TO: PLANNING COMMISSION

**SUBJECT: CLASS 3 DESIGN REVIEW / CLASS 3 SITE PLAN REVIEW / CLASS 2
ADJUSTMENT / CLASS 2 DRIVEWAY APPROACH PERMIT CASE NO.
DR-SPR-ADJ-DAP21-03; 454 CHURCH STREET NE - 97301
AMANDA NOS. 21-109479-DR, 21-109480-RP, 21-113424-ZO, AND 21-
113426-ZO**

Summary: Proposed development of a new mixed-use building including multi-family residential, office and retail uses, and associated site work.

1 FULL BLOCK SITE PLAN
 A0.3 SCALE: 1" = 50'

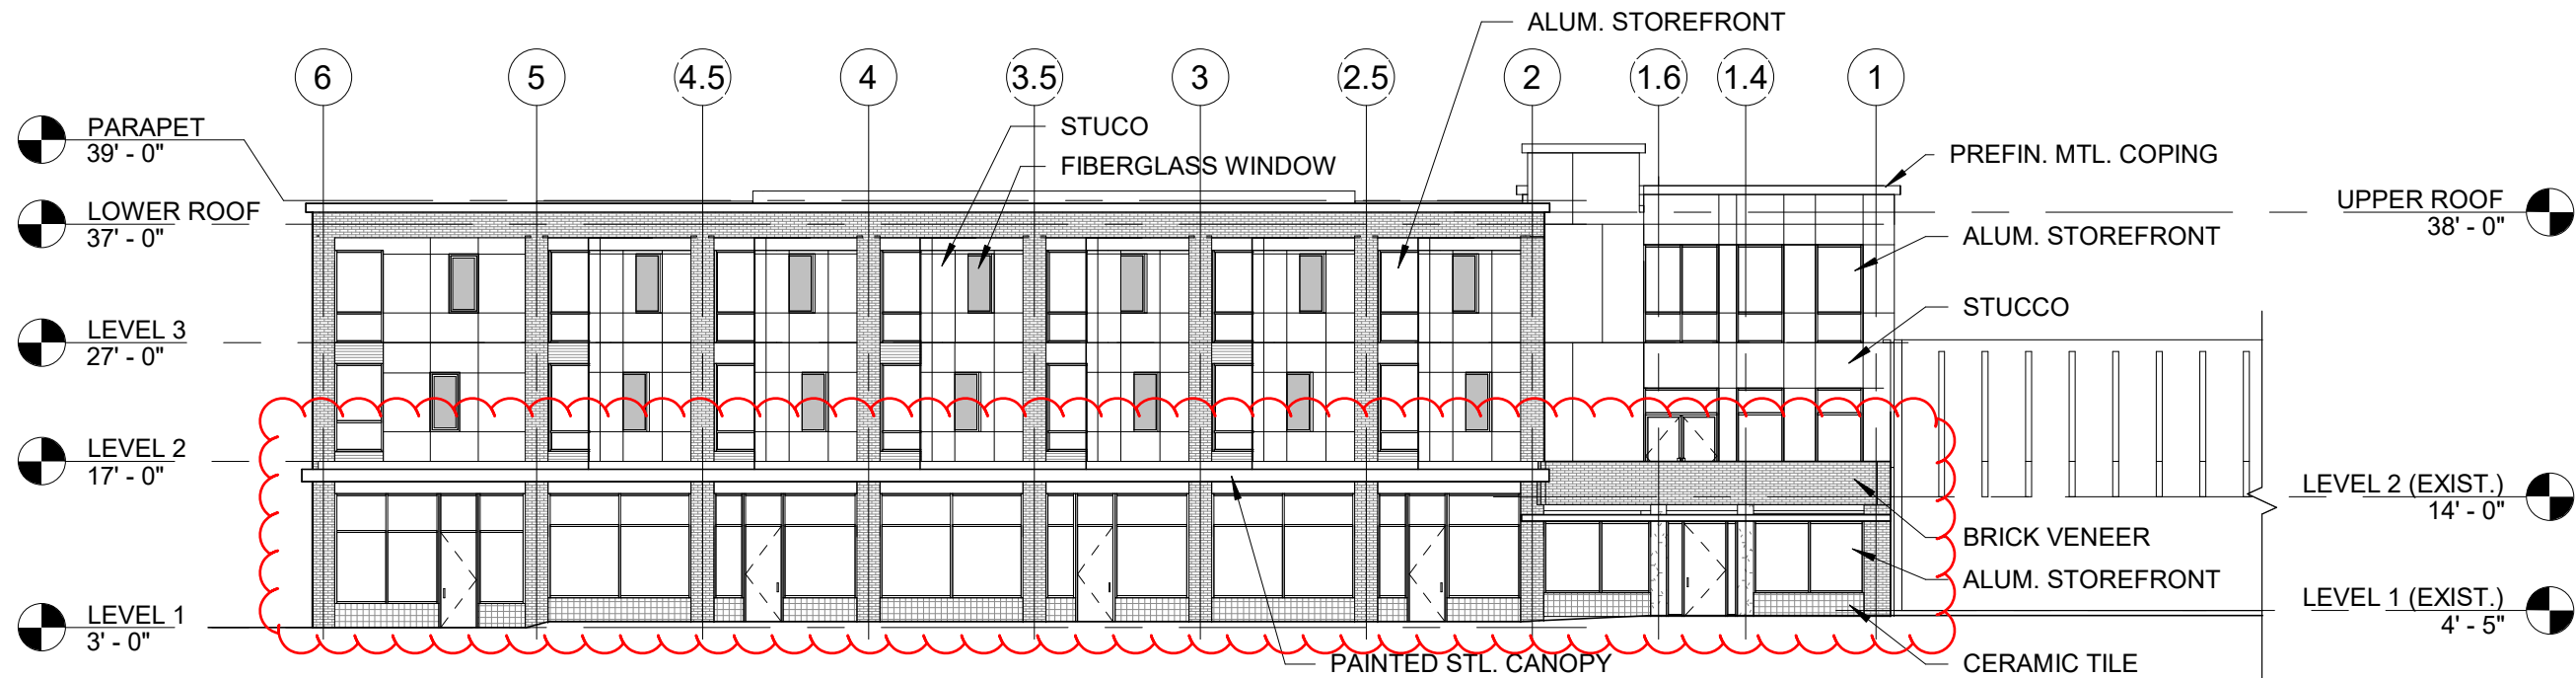
As illustrated on the site plan for the development, the proposed building will be located approximately one-foot to three-feet from the west property line abutting Church Street NE. This does not meet the zero-foot, or ten-foot setback standard abutting streets established in SRC 524.010(b), Table 524-3. The applicant requested a Class 2 Adjustment to the setback standard. Findings for the adjustment request are in Section 10 of this report.

As shown on the site plan for the proposal, 24 standard size stalls are provided. The standard size stalls conform to the minimum required 9-foot width and 19-foot depth. The 45-degree oriented parking stalls within the development are served by 13-foot-wide drive aisle, and in conformance with the requirements of SRC 806.035(e), Table 806-6. The 22 compact parking spaces provided meet the minimum 8-foot width and 15-foot depth standard and are not located adjacent to a wall or pole.

Staff Response: Primary vehicular access to the development is proposed to be provided via the driveway approach accessing the property from Church Street NE. The proposed one-way driveway is approximately 13-feet wide, which meets the minimum 12-foot-wide one-way standard.

Condition 5: Prior to final building permit approval, the applicant shall install one-way signs and/or pavement markings in the parking lot near the driveway approach to Church Street NE.

SHEET: A3.01
DATE: 100% CONST. DOCS.

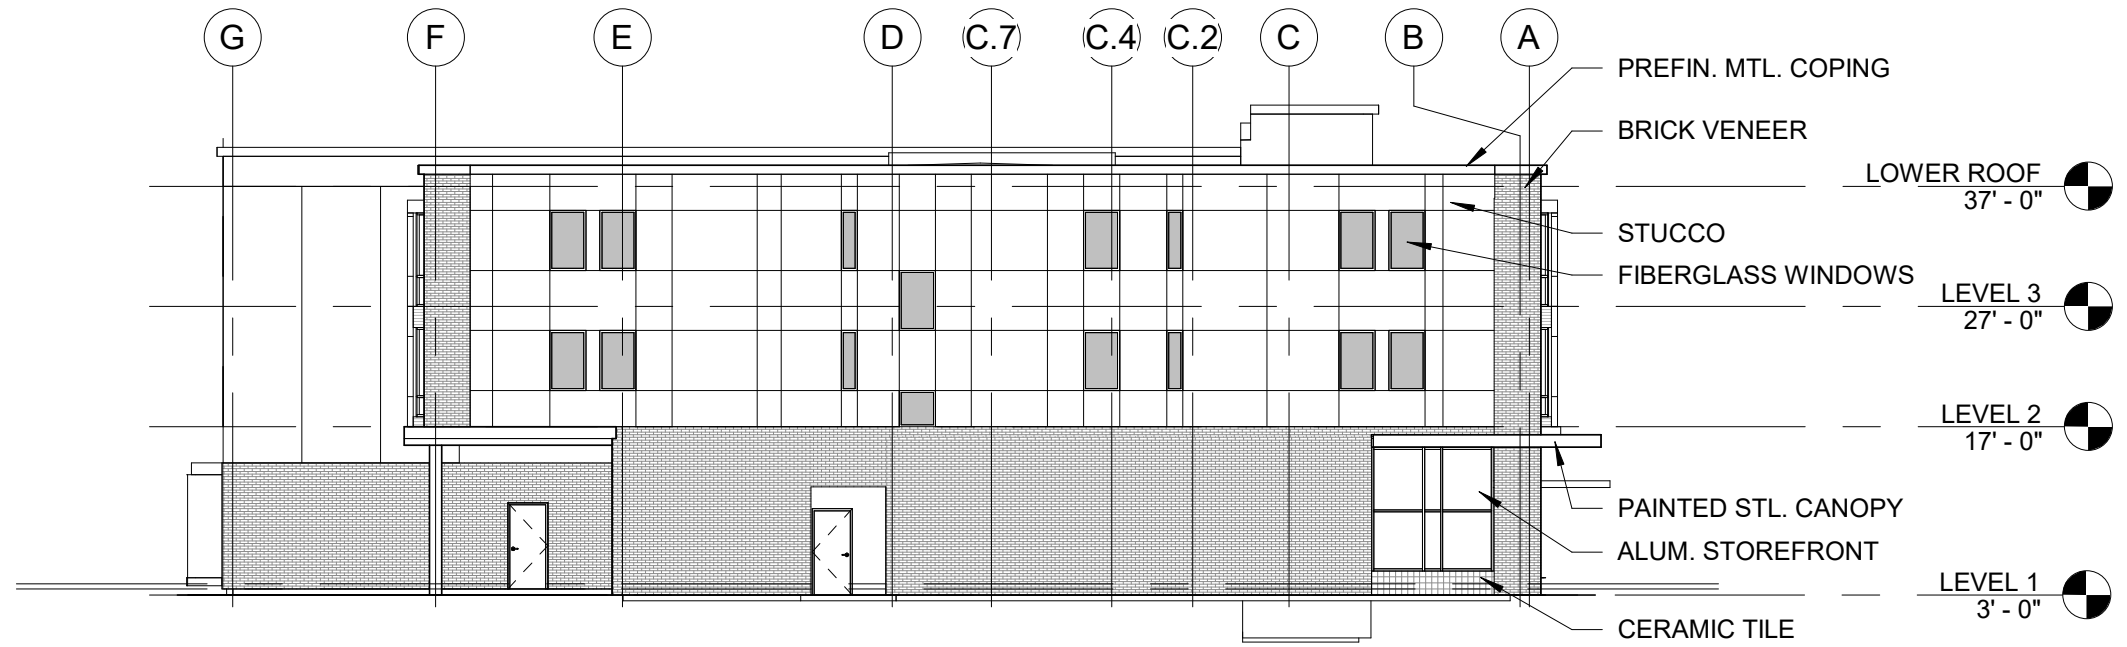
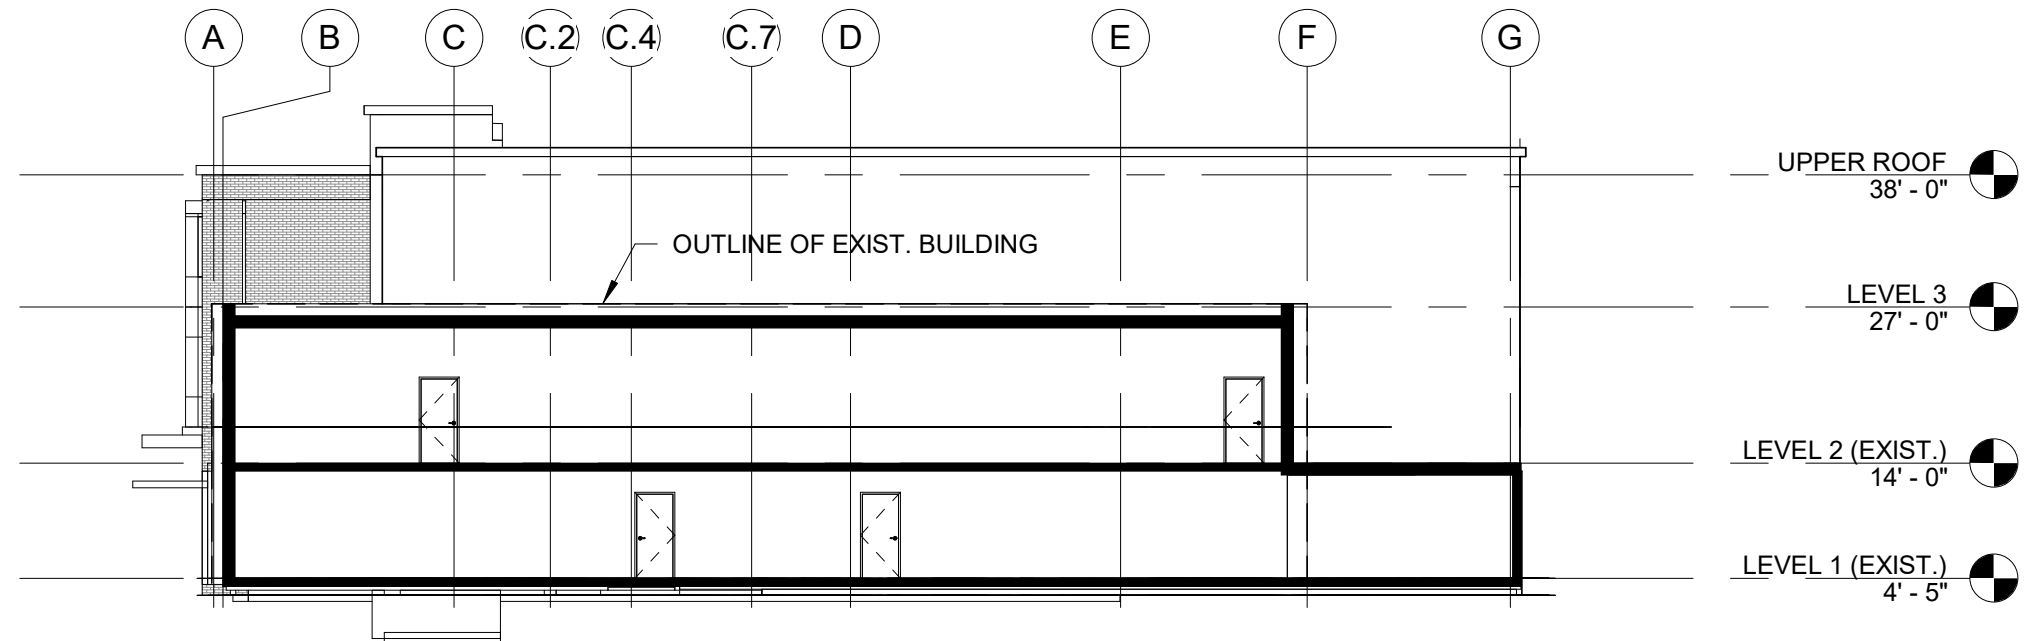
Staff Response: The ground floor of the west facing building façade abutting Church Street NE is approximately 1,374 square feet in size. The applicant's building elevations indicate approximately 1,084 square feet, or 74-percent, is ground floor windows. The applicant's written materials indicate that the visible transmittance rate is 50-percent. This standard is met.

Staff Response: As shown on the applicant's submitted elevations (**Attachment C**) the upper floor windows of the proposed building are vertically oriented. This standard is met.

Staff Response: The applicant's submitted plans and narrative show a steel awning along the entire length of the building's Church Street NE façade. The awning clearance above the sidewalk ranges from eight feet to 11.5 feet in height. Per SRC 76.160, the applicant is required to procure an approved encroachment permit for the awning to project of over the public right-of-way. To ensure an encroachment permit for the awning is obtained, the following condition applies:

Condition 1: The applicant shall obtain a revocable license for the steel canopy encroaching into the right-of-way pursuant to SRC 76.
